SUBJECT: Forwards interpretation of processed data re marine seismic investigation conducted during Jul 1981. Changes to FSAR resulting from interpretation of data will be included in Amend 10 of FSAR.

Re: St. Lucie Unit No. 2  
Docket No. 50-389  
Marine Seismic Investigation  
Interpretation of Processed Data

Insert "A" to St. Lucie Unit 2 FSAR

Pages 2.5-40 and 2.5-40a

SEISMIC PROFILE - LINE 9  
 AIRGUN ENERGY SOURCE  
 SHEET 2 OF 2  
 FIGURE 2.5-42aa

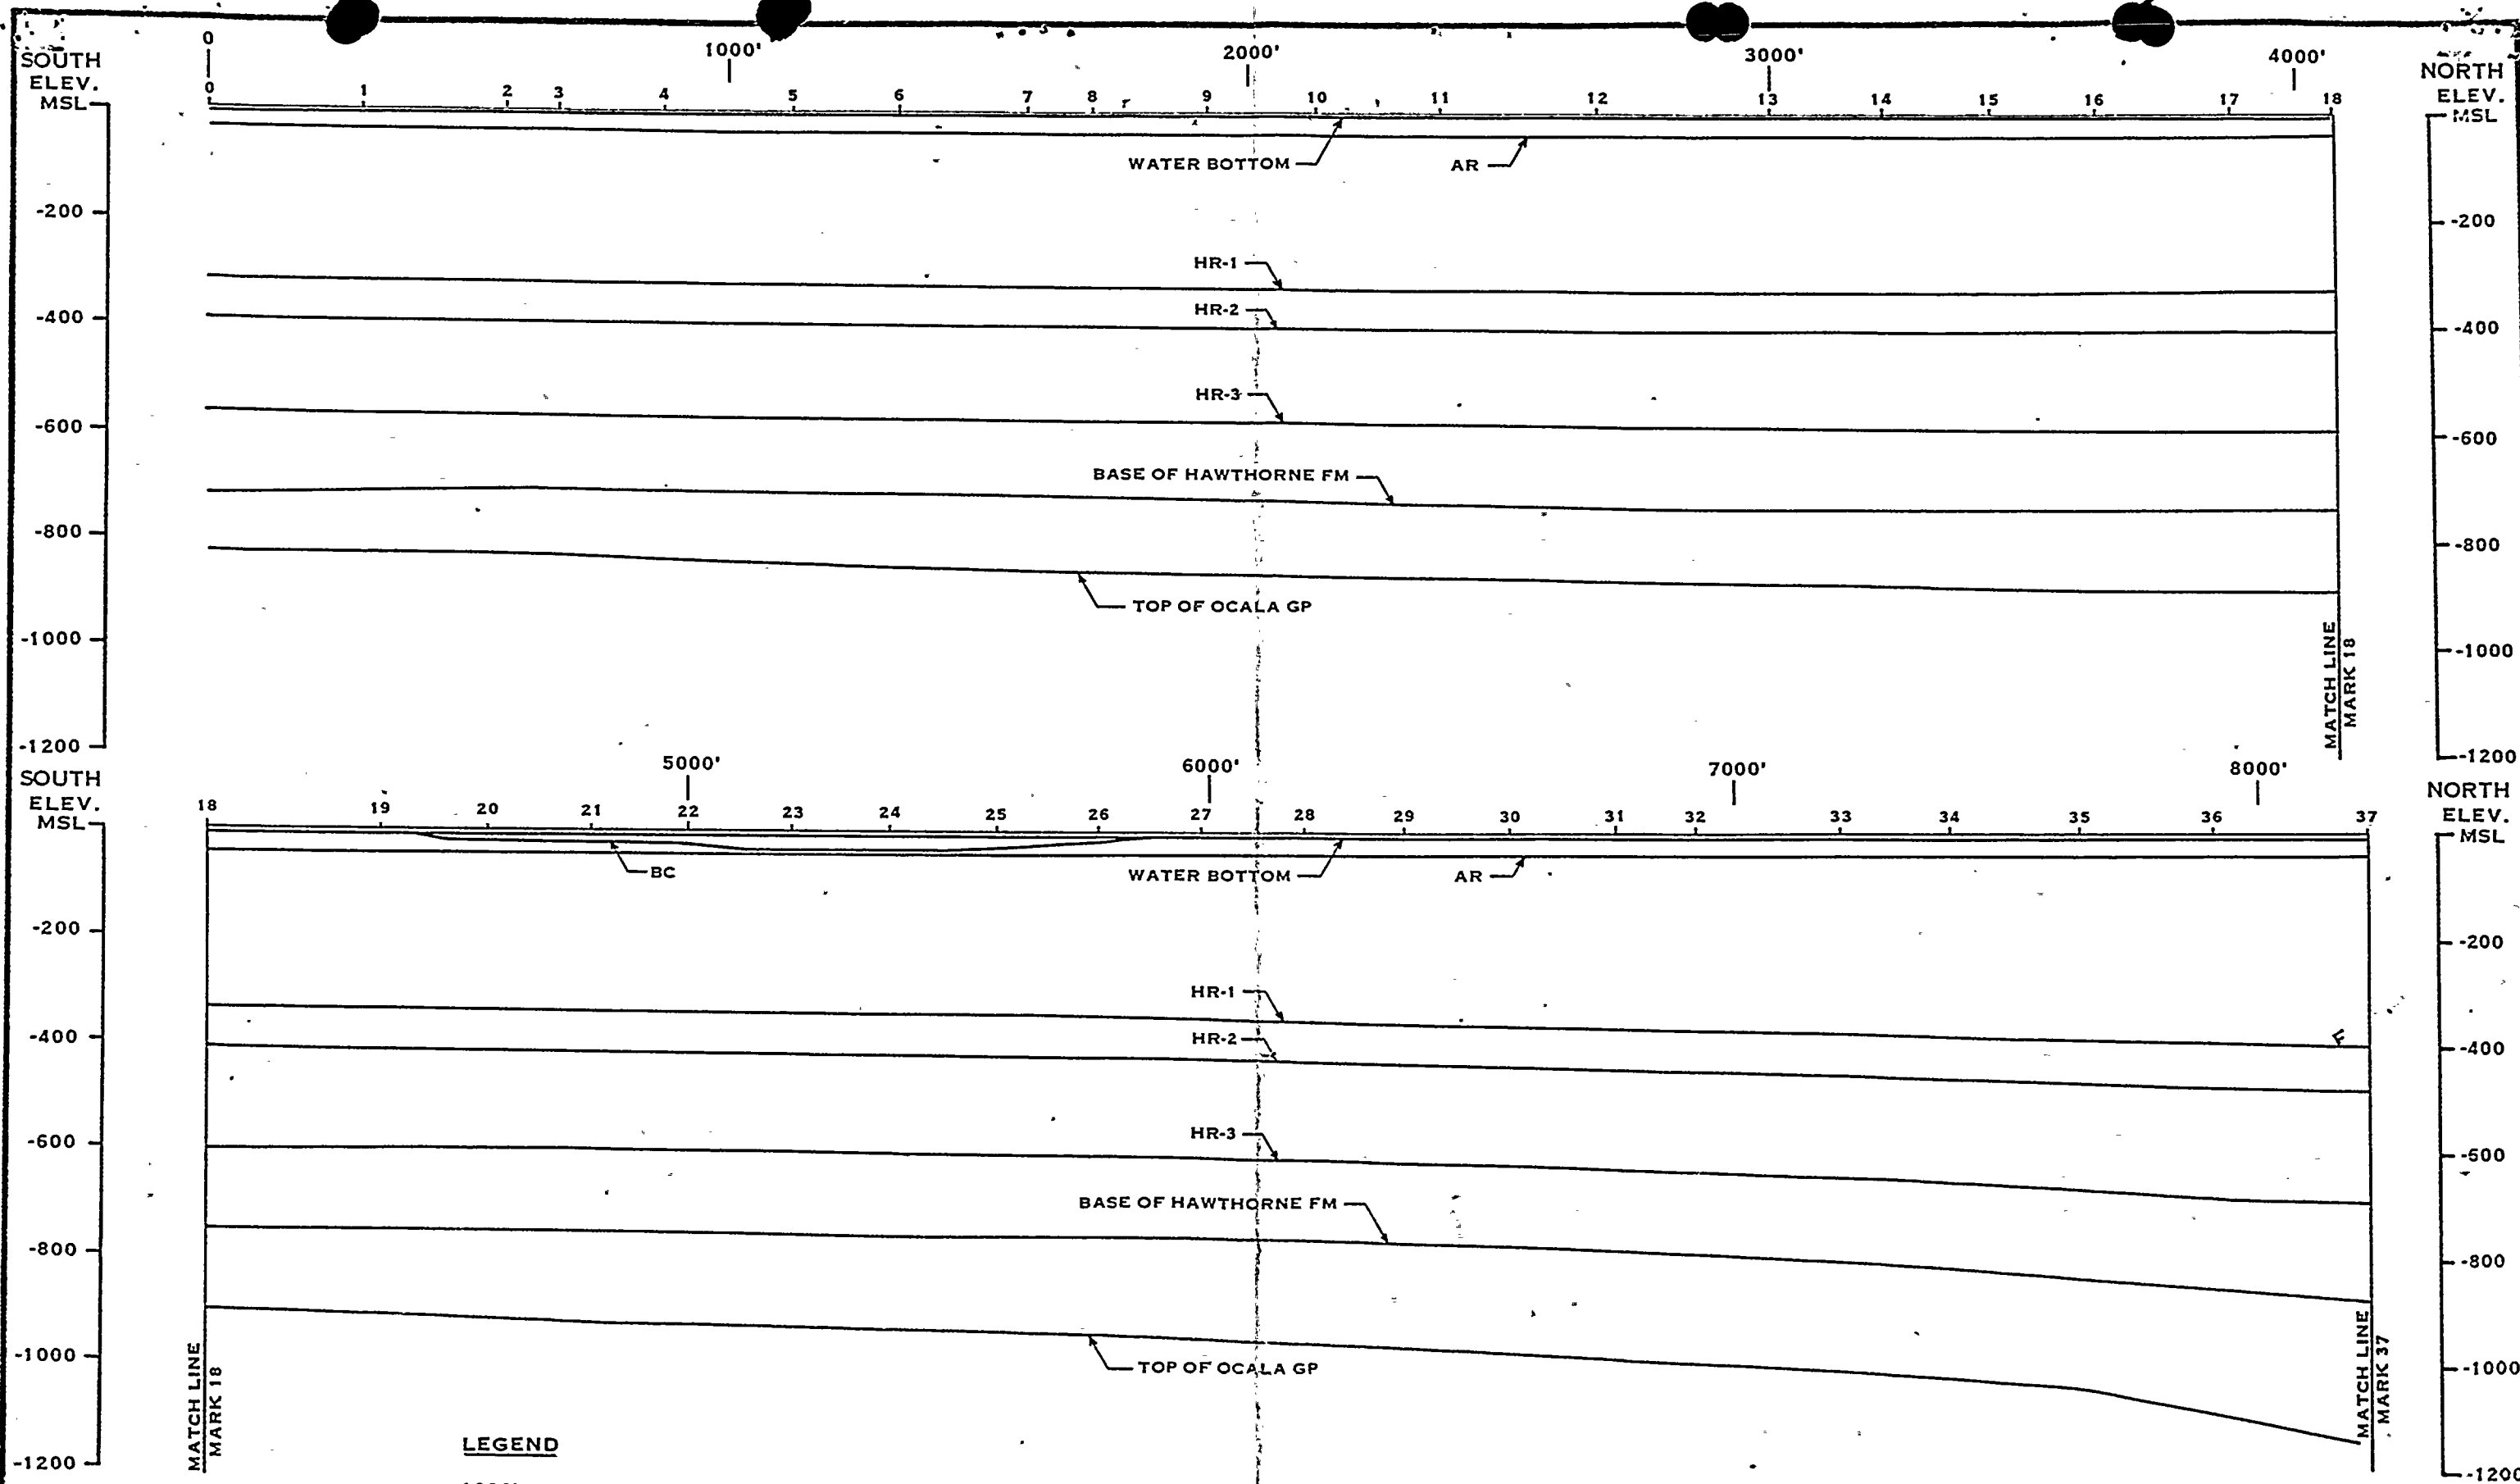
These flexures are most apparent on lines 2, 3, and 6(b) (Figures 2.5-42p, q, and w). The apparent dip of the base of the Hawthorne Formation averages about 59 feet per mile and ranges from over 400 to nearly 1,000 feet per mile at certain points along lines 2, 3, 4 and 9 (Figures 2.5-42p, q, s and aa). The apparent dip of the top of the Ocala Group, which is generally steeper than the dips of the overlying horizons, averages about 123 feet per mile but reaches over 1,000 feet per mile on lines 2 and 9 (Figures 2.5-42p and aa).

SEISMIC PROFILE - LINE 3  
AIRGUN ENERGY SOURCE  
SHEET 2 OF 2  
FIGURE 2.5-42q

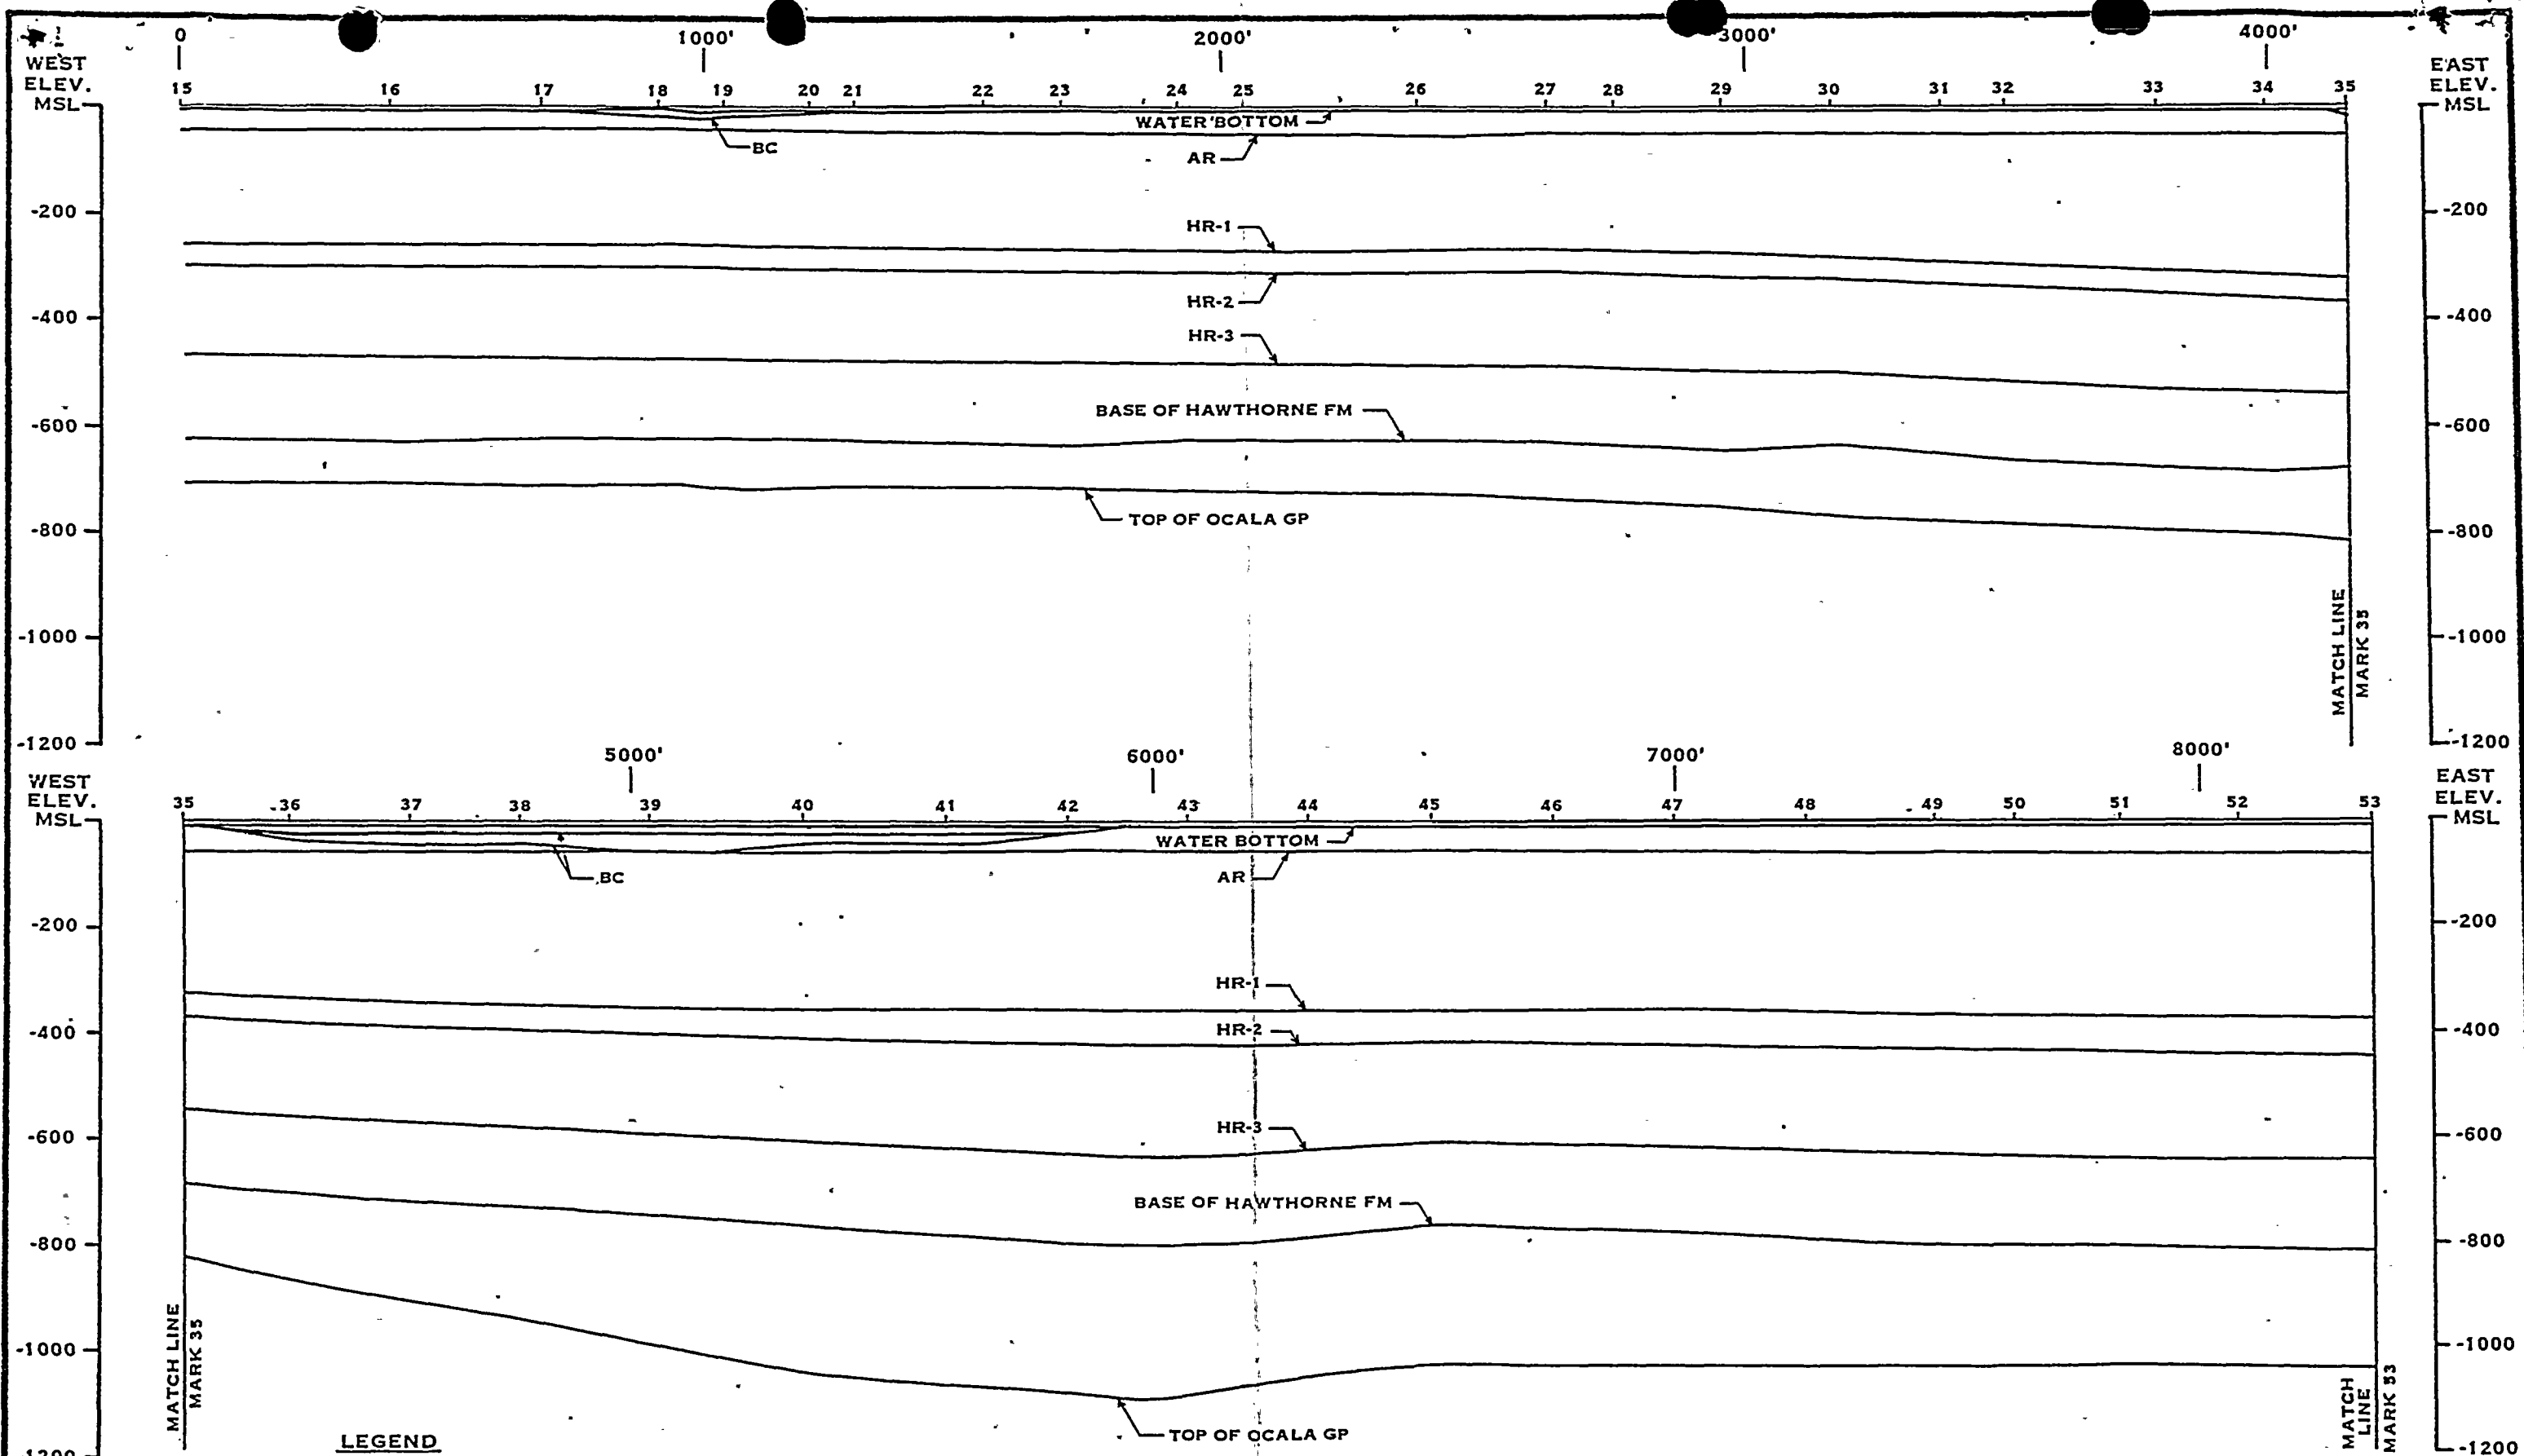
~~These are most apparent on lines 2, 3, 5 and 6(B) (Figures 2.5-42p, 2.5-42q, 2.5-42u and 2.5-42w. The dip of the upper horizons (base of Hawthorne Formation and above) on these features averages 150 ft. per mile~~

~~but increases to over 400 ft. per mile on line 2 and line 6(B). The top of the Ocala Group generally has a steeper dip than the overlying horizons (Figures 2.5-42p, 2.5-42q, 2.5-42u and 2.5-42w, and reaches about 550 to 850 ft. per mile on lines 2 and 6(B) (Figures 2.5-42p and 2.5-42w).~~
